DATE: FEBRUARY 13, 2014
TO: HONOURABLE MAYOR AND MEMBERS OF COUNCIL
FROM: LEO GRELLETTE, DIRECTOR OF BUILDING STANDARDS DEPARTMENT
RE: **COMMUNICATION
COUNCIL MEETING – FEBRUARY 18, 2014**

**SIGN VARIANCE APPLICATION
FILE NO: SV.13-014
OWNER: 1051727 ONTARIO LTD.
LOCATION: 5289 AND 5309 HIGHWAY 7
LOT 5-9, REGISTERED PLAN 3762**

NORTH WALL
FACING HWY 7

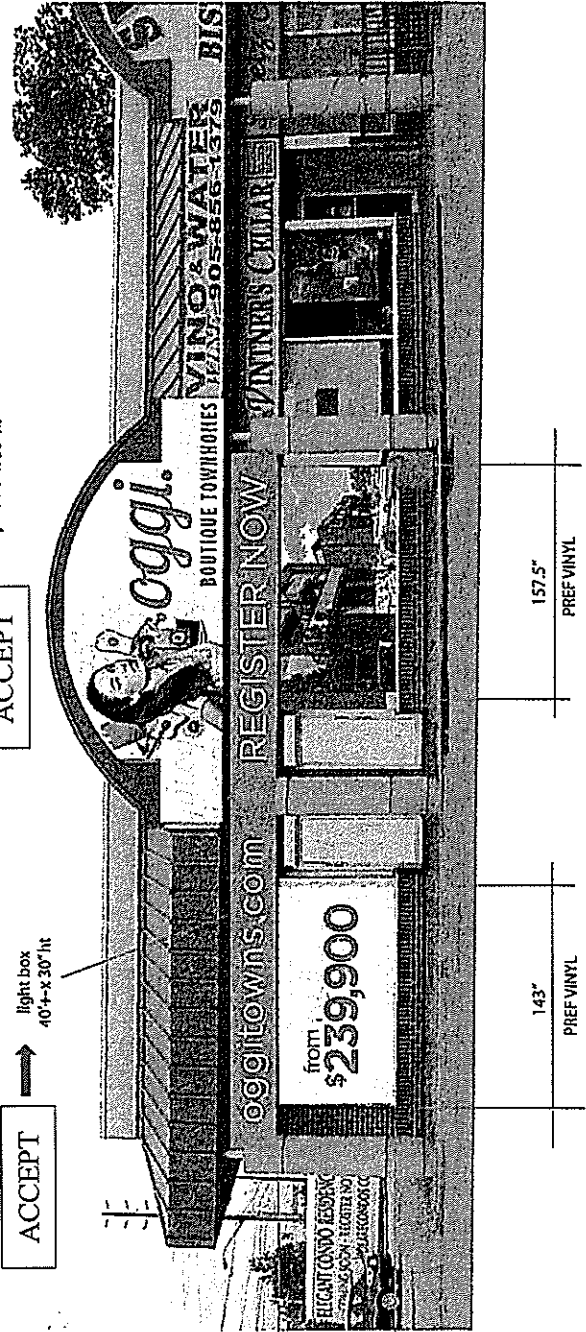
Staff, during the Committee of the Whole meeting, discussed the refusal with the owner. Staff proposed what they might deem acceptable, being the three small box signs on the North Wall and the one continuous box sign on the West Wall. Staff also told the owner that they would accept one of the larger 'oggi Boutique Townhomes' signs which could be placed on either the North or West Wall.

In the course of discussion the owner was told that all other signs had to be removed.

ACCEPT

ACCEPT

ACCEPT

ACCEPT

ACCEPT
